# *NS9210/NS9215 Errata*

Part number/version: 90002007\_C

Release date: November 2010

**SPI: Extra clock inserted in modes 1, 2, and 3**

**SPI Mode 1****Workarounds:**

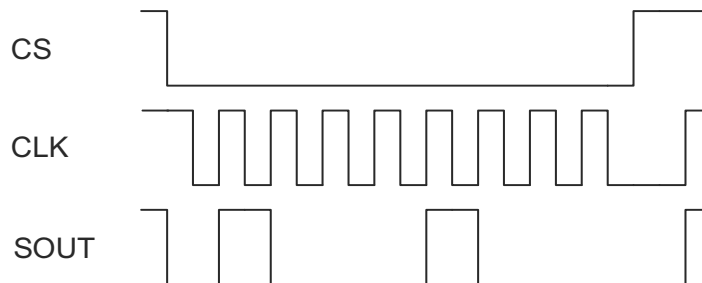
In SPI modes 1, 2, and 3 an unexpected additional clock is inserted after the last byte is transmitted. See timing diagrams below. A portion of the unexpected clock cycle occurs while CS is asserted. Unless the SPI device connected to the NS9210/NS9215 port is capable of handling this unexpected behavior, this may cause SPI communication issues.

- Select SPI Mode 0 instead and enable the inversion function using the INV bit (D01) in the corresponding GPIO Configuration Register of SPI CLK. This workaround will also be integrated as an option in a future version of the NET+OS SPI driver API.
- FIM-based SPI port with support for SPI Mode 1.
